Re: Application 221-29, CRI application, South End Pacific LLC
670 Pacific Street, Fire House
648 Pacific Street, Tabernacle of Grace Church
171 Henry Street

Subject: Application 221-29: South End Pacific, LLC – Coastal Site Plan Review, Site and Architectural Plans and/or Requested Uses and a Special Permit

**RE: ZB APPLICATION #221-29 - SOUTH END PACIFIC, LLC (Contract Purchaser) -
648, 670, 686 & 690 PACIFIC STREET and 171 HENRY STREET - Site & Architectural
Plans and/or Requested Uses and Special Permit**

**Subject: 171 Henry Street
648-690 Pacific Street
Zoning Application No. 221-29**

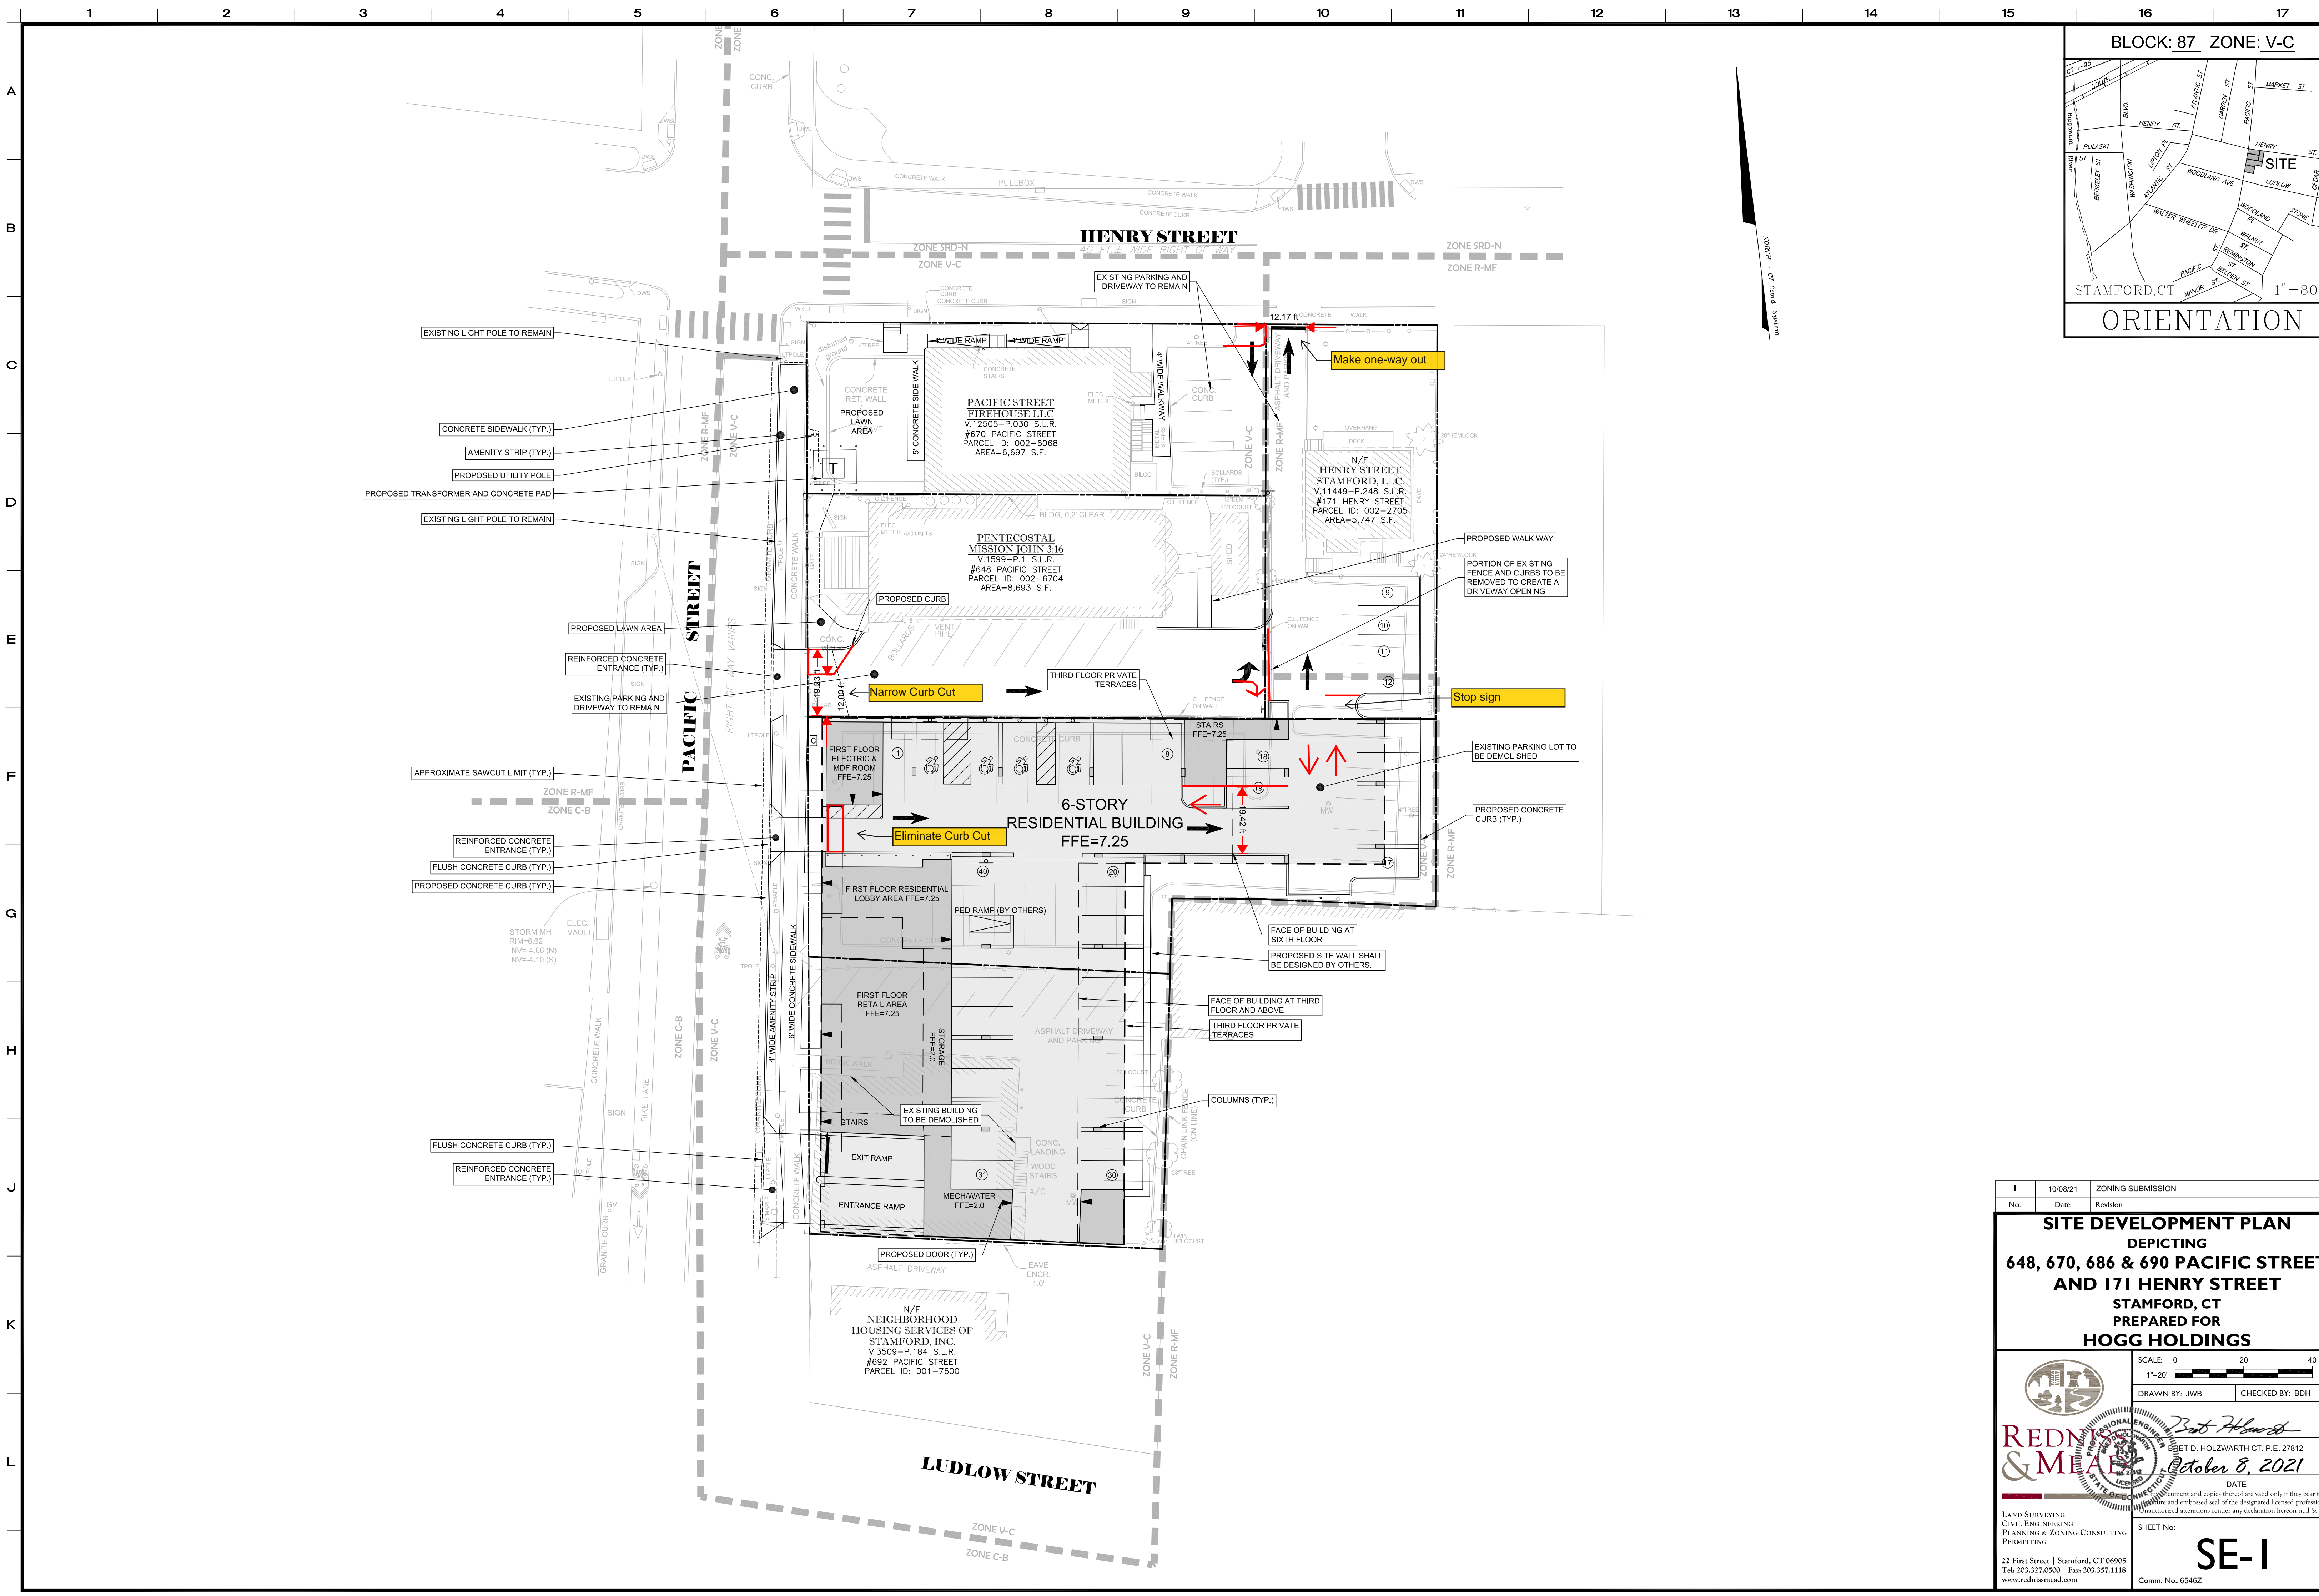
SE-1

1. The high frequency of Curb Cuts and width of curb cuts for this development do not align with the spirit of the V-C regulations and have a negative effect on pedestrian safety and mobility by increasing the number of opportunities for pedestrian & vehicular conflicts. The Department is strongly against the number of Curb Cuts on this site due to the potential safety hazards to pedestrians. The below comments are related to the Site's proposed curb cuts. Please see attached plan titled "221-29 TTP revised Curb Cut and Site Circulation Drawing" for a visual explanation of the Department's curb cut reconfiguration.

- b. The northern access drive on Pacific Street curb cut is too wide and shall be revised to 12' wide to comply with zoning regulations
2. All sidewalk curbing shall be in granite. Revise on all plans
